# ALTERNATIVES EVALUATION REPORT LOWER ALAMEDA CREEK/BART WEIR FISH PASSAGE ASSESSMENT

December 14, 2006

*B COMMITTEE REVIEW COMMENTS*

Figure 1 – Extended Fish Ladder Alternative

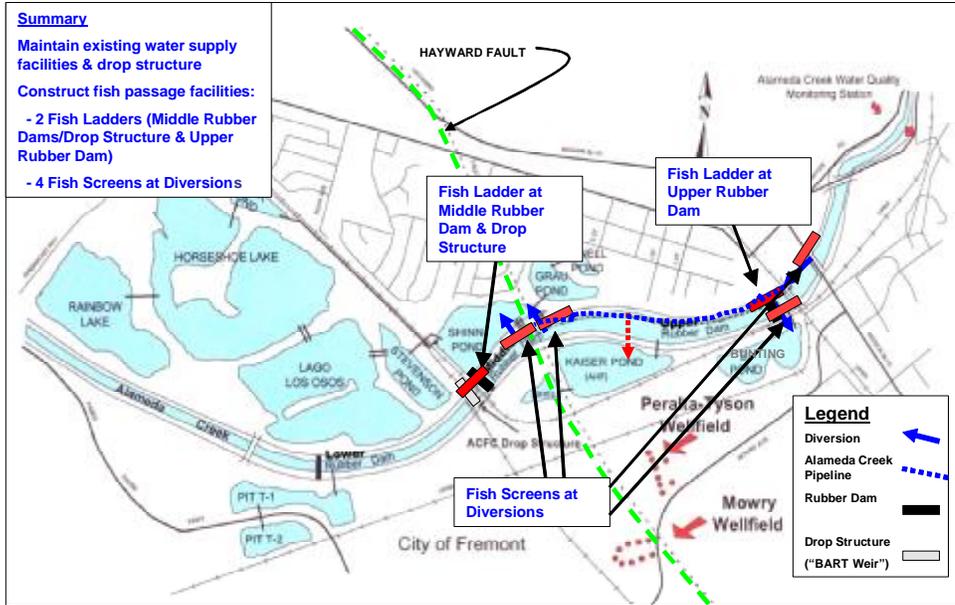
4. ACWD planning considerations for Middle Rubber Dam passage alternatives: ACWD is currently evaluating various alternatives for fish passage at the Middle Rubber Dam, including: (1) an extended fish ladder that provides passage past both the BART Weir and Middle Rubber Dam (see Figure 1, evaluated as the "Extended Vertical Slot" alternative in the draft BART Weir Passage report.); and (2) re-operating the Middle Rubber Dam such that it is deflated during the winter/spring migration period (see Figure 2, evaluated as the "roughened channel" and "reduced vertical slot" alternatives). The "re-operation" alternative

- a. Redundancy/reliability: The extended fish ladder alternative will provide ACWD with two operating rubber dams (and associated screened diversions) throughout the year. Given the proximity of Hayward Fault to these facilities, this is an important consideration for ACWD. With the potential failure of one dam, the other dam could still be utilized for water diversions through screened intakes. In addition, routine maintenance of ACWD's facilities above the Upper Rubber Dam (as well as other in-channel projects, such as the recent Mission Bridge project) may require that ACWD keep the Upper Rubber Dam deflated for a long period. Without the use of the Middle Rubber Dam and associated diversions (as considered under the re-operation alternative), this may have a significant impact on ACWD's water supplies.

Figure 2 – Roughened Channel/Reduced Vertical Slot Alternative (Re-operation Alternative)

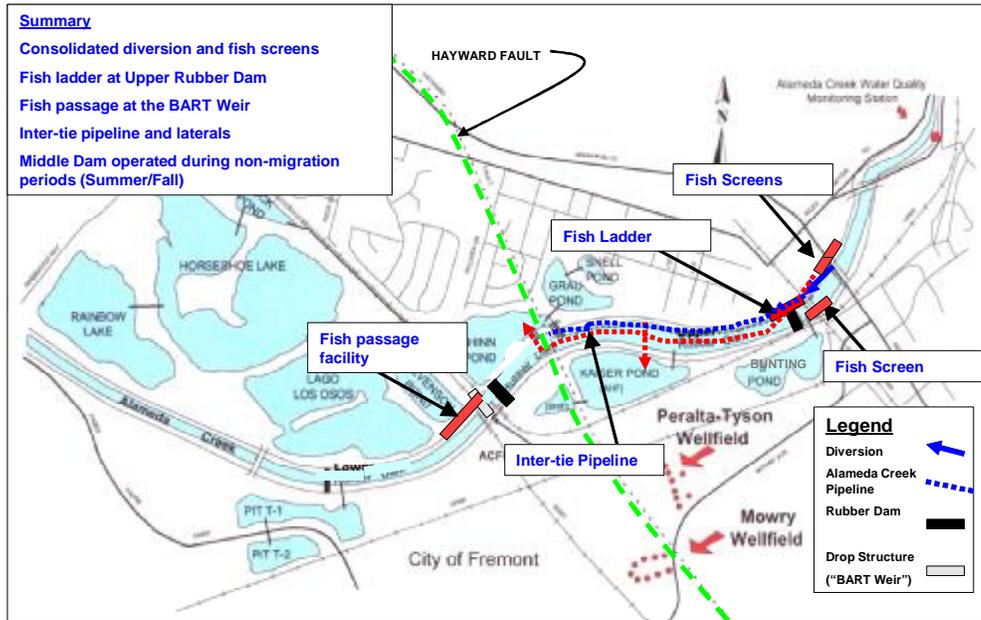
- b. Operational flexibility: Maintaining two rubber dams operational throughout the winter and spring months (i.e. the extended fish ladder alternative) would also maintain existing operational flexibility for water supply operations. For instance, water could be supplied through screened diversions to the Quarry Lakes recharge pits via the Upper Dam, Middle Dam or both. In addition, maintaining the two rubber dams operational during the winter/spring would improve ACWD's capability to recharge water under high flow conditions. This operational flexibility may also provide benefits for fish passage. For instance, under certain conditions, a potential operating scenario after a high flow event may be to inflate the Middle Rubber Dam first, followed by inflating the Upper Rubber Dam at a later time. Under this operating scenario, a window of opportunity may be provided such that in-migrating steelhead would only need to pass through one fish passage facility in the flood control channel (the extended fishway), in order to access the upper watershed.
